CAB-33-07

LIGHTS - LED NAV/ANTI-COLLISION LIGHT WIRING MODIFICATION

March 25, 2020

Figure 1. LED NAV/Anti-Collision Light Wiring Modification (Before Modification) (Sheet 1)

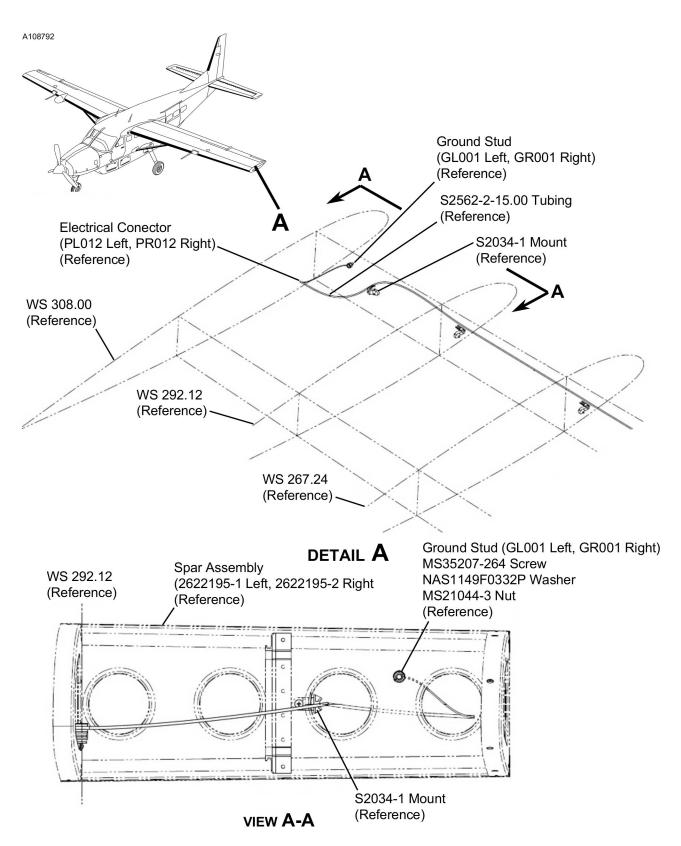
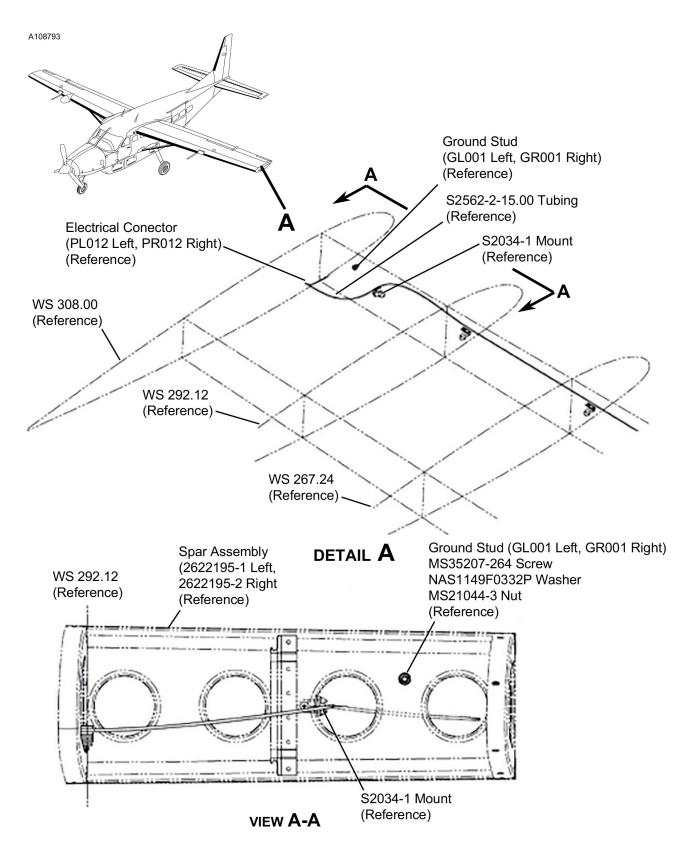
Field reports indicate that the magnetometer is experiencing Red-X situations. It was found that the Red-X was caused by the LED Nav/Anti-Collision Lights. Removal of the ground shield eliminates the interference with the magnetometer.

This service bulletin provides parts and instructions to remove a ground shield from the wiring for the LED NAV/Anti-Collision Light.

- 4. (Refer to Figure 1, View A-A.) Remove the terminal ends from the GL001 (Left) and GR001 (Right) Ground Studs on the 2622195-1 (Left), 2622195-2 (Right) Spar Assemblies.
 - A. Install the removed hardware on the ground studs and tighten.

- 5. Cut the shielded wire to remove the terminal end that was removed from the GL001 (Left), GR001 (Right) Ground Studs.
- 6. Install the TC4001 End Cap on the end of the shielded wire. (Refer to the Model 208/208B Maintenance Manual, Chapter 20, Bonding and Grounding Maintenance Practices.)
 - A. Heat shrink the TC4001 End Cap until it has shrunk firmly around the shielded wire.

- 7. (Refer to Figure 2, Detail A.) Install the S2562-2-15.00 Tubing between PL012 (Left), PR012 (Right) Electrical Connectors and the S2034-1 Mount.
- 8. Install the LED NAV/Anti-Collision Light (FL003 Left, FR003 Right). (Refer to the Model 208/208B Maintenance Manual, Chapter 33, LED NAV/Anti-Collision Lights Removal/Installation.)
- 9. Remove the maintenance warning tags and connect the airplane battery.
- Make an entry in the airplane logbook that states compliance and method of compliance with this service document.
